# UNITED STATES PATENT AND TRADEMARK OFFICE

APPLICATION NO.	FILING DATE	FIRST NAMED INVENTOR	ATTORNEY DOCKET NO.	CONFIRMATION NO.
10/051,304	01/22/2002	David W. Vos	13232.00023	5251

**Office Action Summary**

## DETAILED ACTION

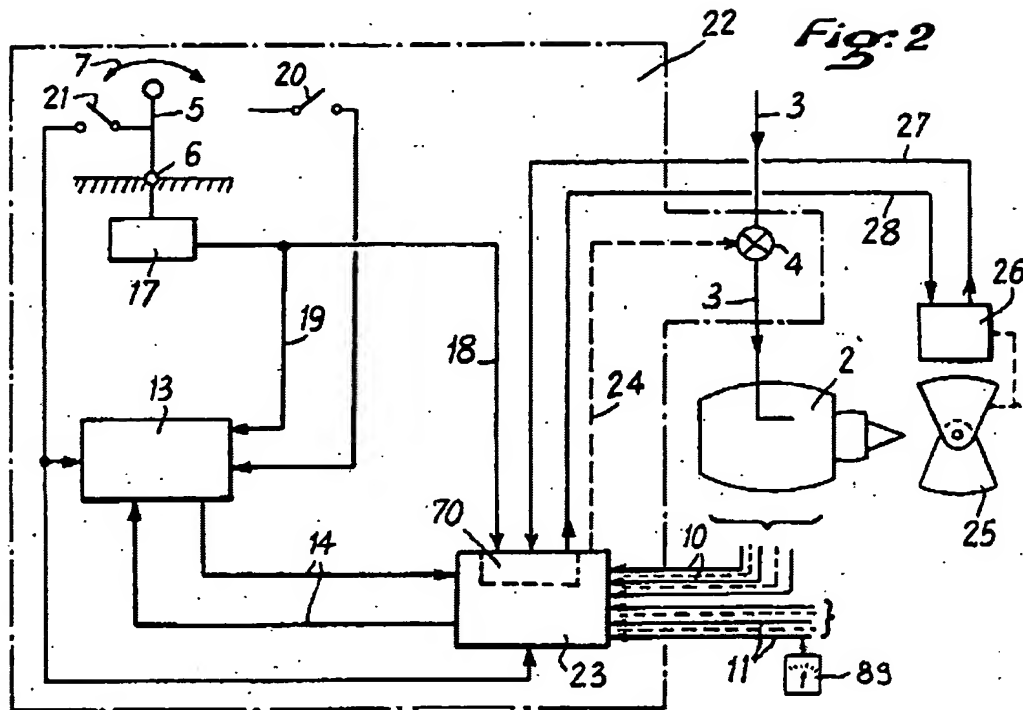
7. Claims 1 and 13 are rejected under 35 U.S.C. 102(b) as being anticipated by **Cavasa et al. (U.S. 4,686,825)**.

**Cavasa** teaches an apparatus comprising: an input means 5 for generating a output power command; and a processor 23 coupled to said input means 5 for a) receiving the generated output power command, b) receiving a plurality of detected ambient air conditions 11 (see column 6 lines 8-10), c) receiving a plurality of detected power plant performance parameters 10 (see column 6 lines 4-6), d) determining first and second power plant control commands (control of fuel valve 4; and control of thrust reverser 25) based on the received output power command, the detected ambient air conditions, and the power plant performance parameters, e) and outputting first and second output signals (24, 28) respectively corresponding to the first and second power plant control commands. See particularly **Figure 2** of Cavasa.

FIG. 2

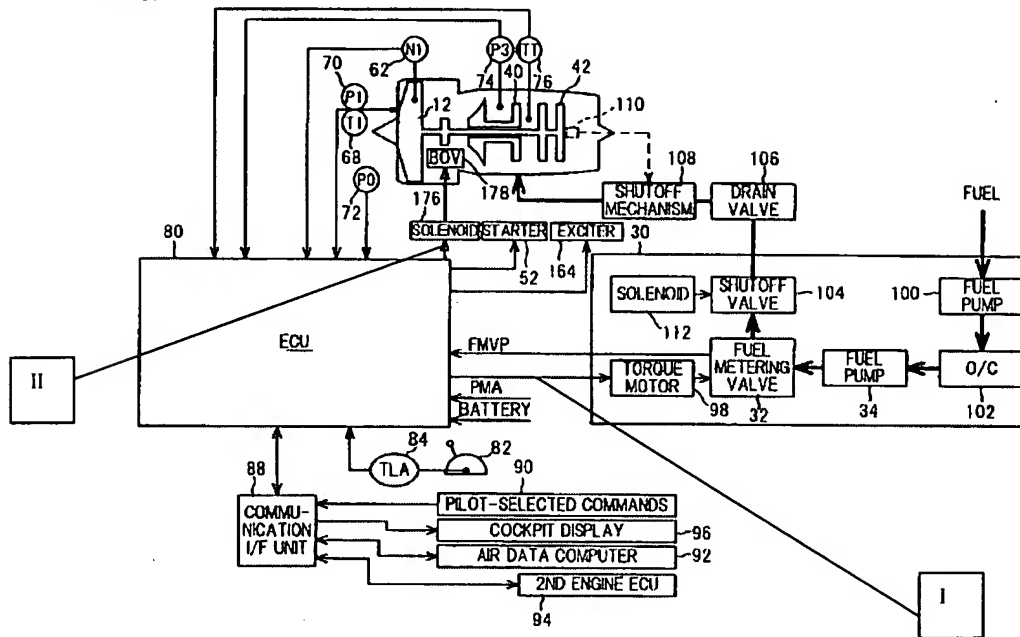
8. Claims 1 and 13 are rejected under 35 U.S.C. 102(e) as being anticipated by **Hattori** (U.S. 6,434,473).

**Hattori** teaches an apparatus comprising: an input means 82 for generating a output power command; and a processor ECU coupled to said input means 82 for a) receiving the generated output power command, b) receiving a plurality of detected ambient air conditions (68, 70, 72), c) receiving a plurality of detected power plant performance parameters (74, 76), d) determining first and second power plant control commands (control of fuel valves; and control of bleed valve 178) based on the received output power command, the detected ambient air conditions, and the power plant performance parameters, e) and outputting first and second output signals (I, II) respectively corresponding to the first and second power plant control commands. See particularly **Figure 2** of **Hattori**.
